# UNITED STATES PATENT AND TRADEMARK OFFICE

**Office Action Summary**

10/767,743

BAUER, CHRISTIAN

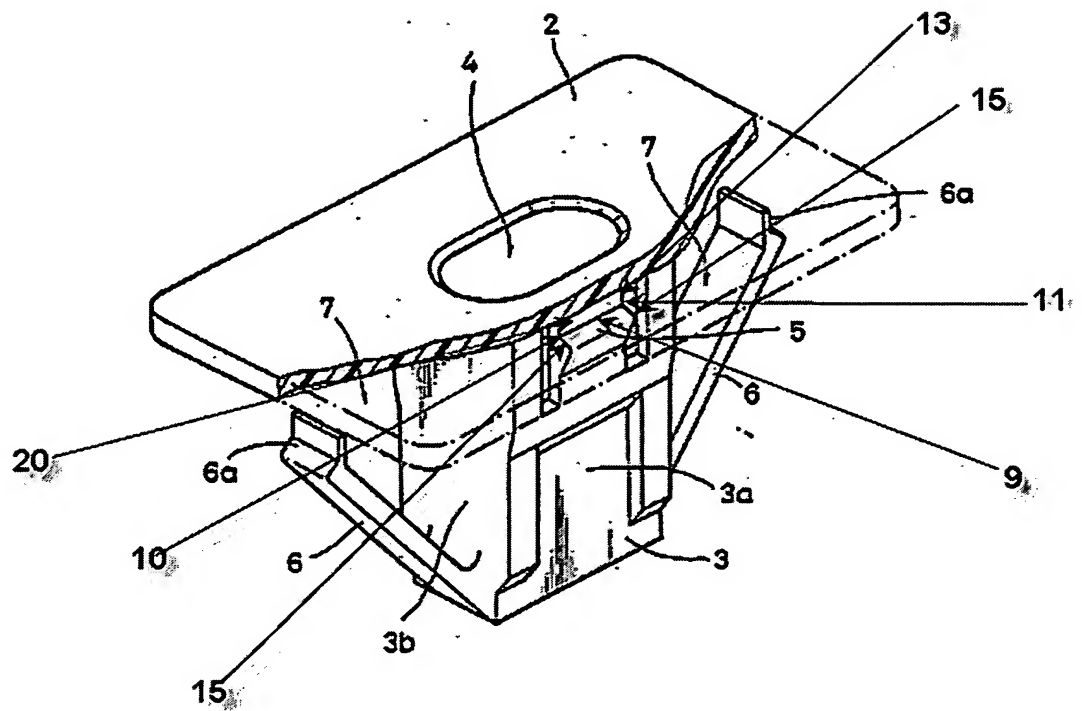
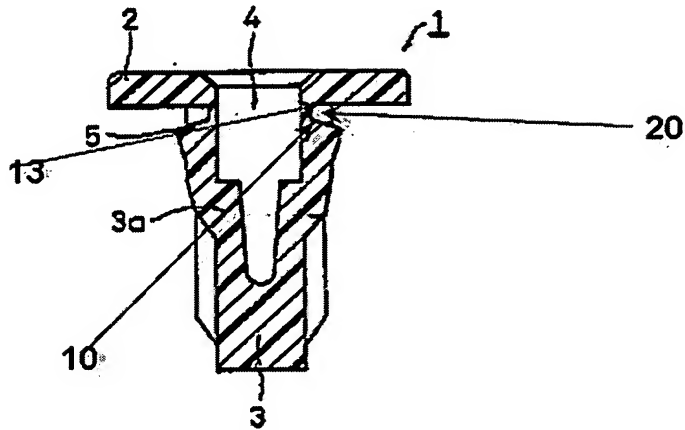
As for Claim 6, Sato teaches of a fastener (1, see figures below) adapted to be inserted into an opening of a sheet member (11) having opposite upper (2) and lower surfaces (3), said fastener (1) comprising:

a shank (3) extending in an axial direction of said grommet and having opposite upper (2) and lower ends (1);

at least a locking tab (6a) coupled to said shank (3) between the upper (2) and lower ends (3) of said shank (3) and radially flexible relative to said shank (3); and

a head (2) connected to the upper end of said shank (3) and comprising a flange (2) adapted to engage the upper surface of the sheet member (11) when said shank (3) and said locking tab (6a) are snapped into the opening (12);

wherein said shank (3) comprises

a shoulder (5) in a region adjacent the head (2), said shoulder (5) being adapted to be placed below an edge of the opening (12) when said shank (3) is moved transversely to said axial direction after being snapped into the opening, thereby preventing withdrawal of said shank (3) from said opening (12); and

an outer surface section (20) inclined relative to the axial direction and connecting said shoulder (5) and the lower surface of said head (2), for engaging the edge of the opening (12) and drawing said shank (3) into the opening (12) when said shank (3) is moved transversely to said axial direction; and

wherein, when said shank (3) is seen in said axial direction, said shoulder (5) is confined between an outer edge (15) of said shank (3) and a first boundary line (9) intersecting said outer edge (15) at first (10) and second points (11), and said outer surface section (20) is confined between said first boundary line (9) and a second boundary line (13) converging toward the first point (10).

[8] Applicant's arguments filed 2/1/2006 regarding rejections under 35 U.S.C. 102 have been fully considered but they are not persuasive. With regard to the amended subject matter, the examiner directs the applicant to the figures above showing how the claim language in the instant set of claims, when viewed with the broadest reasonable interpretation, are anticipated by the figures of Sato.
